Distr.
GENERAL
TRANS/WP.29/2003/33
4 April 2003

PROPOSAL FOR DRAFT SUPPLEMENT 2 TO REGULATION No. 99

(Gas-discharge light sources)

Transmitted by the Working Party on Lighting and Light-Signalling (GRE)

"Annex 5

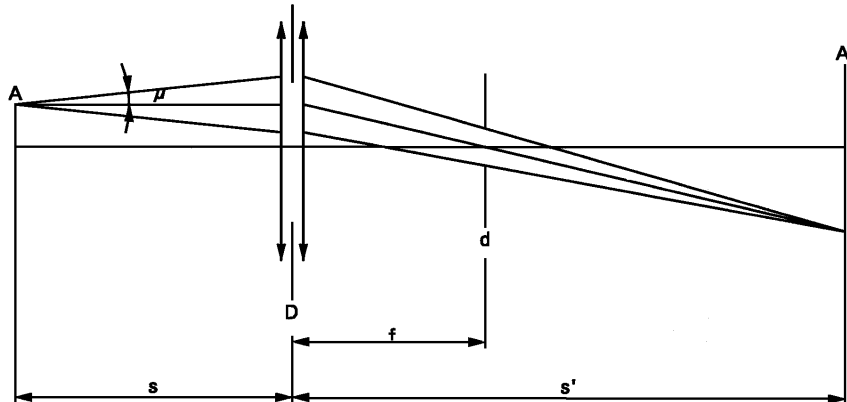
Annex 5, amend to read:

The gas-discharge light source shall be positioned as shown:

- in figure 1 or figure 2 on sheet DxR/1 or sheet DxS/1;
- in figure 3 or figure 4 on sheet DxR/2 or sheet DxS/2.

An optical system shall project a real image A' of the arc A with a magnification of preferably $M = s'/s = 20$ on a screen. The optical system shall be aplanatic and achromatic. In the focus-length f of the optical system a diaphragm d shall cause a projection of the arc with nearly parallel observation directions. To get the angle of the half divergence not larger than $\mu = 0.5^\circ$, the diameter of the focus-diaphragm with respect to the focus-length of the optical system shall be not more than $d = 2f \tan(\mu)$. The active diameter of the optical system shall be not more than:
 $D = (1 + 1/M)d + c + (b_1 + b_2)/2$. (c , b_1 and b_2 are given on sheet DxS/5, respectively sheet DxR/5).
